LiDAR Quality Assessment Report

AR_FEMA-UPPER-BLACK-
WATERSHED_2012

FEMA VI - Upper Black Watershed Lidar

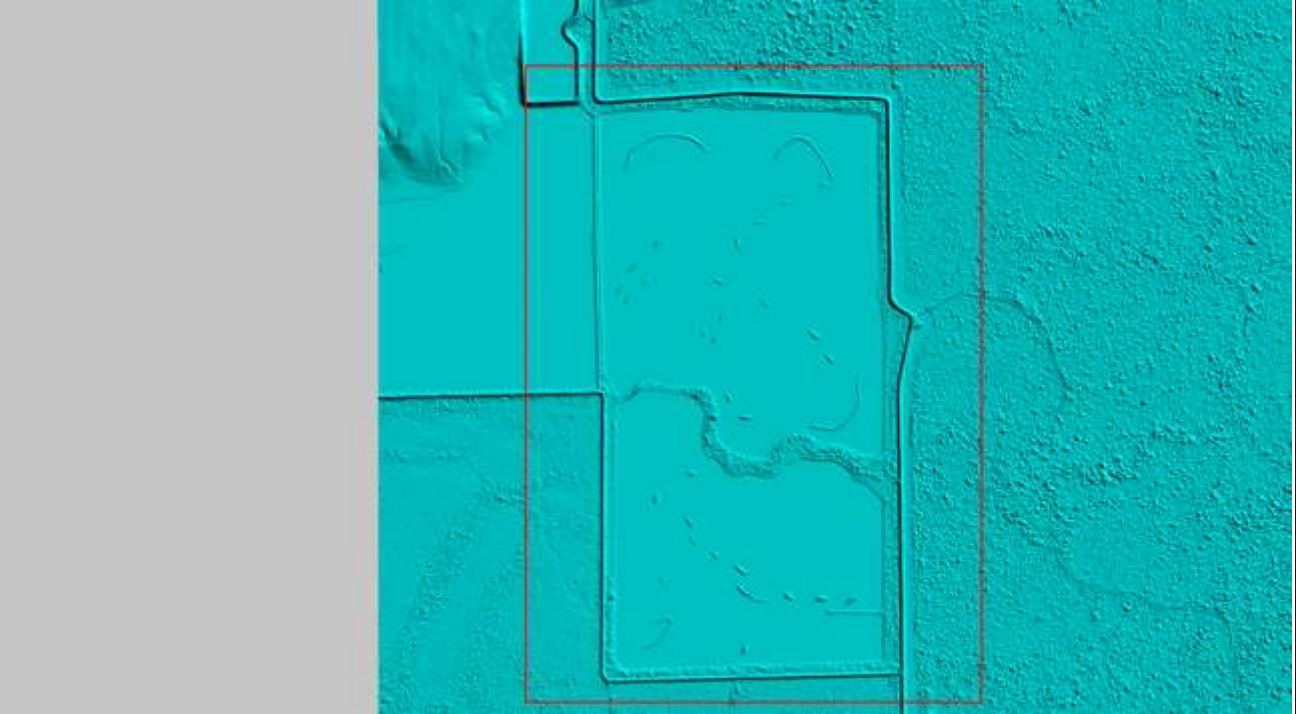
Area of non-water has been hydro-flattened at $36^{\circ} 18' 12.4977''$ N, $90^{\circ} 45' 28.4201''$ W
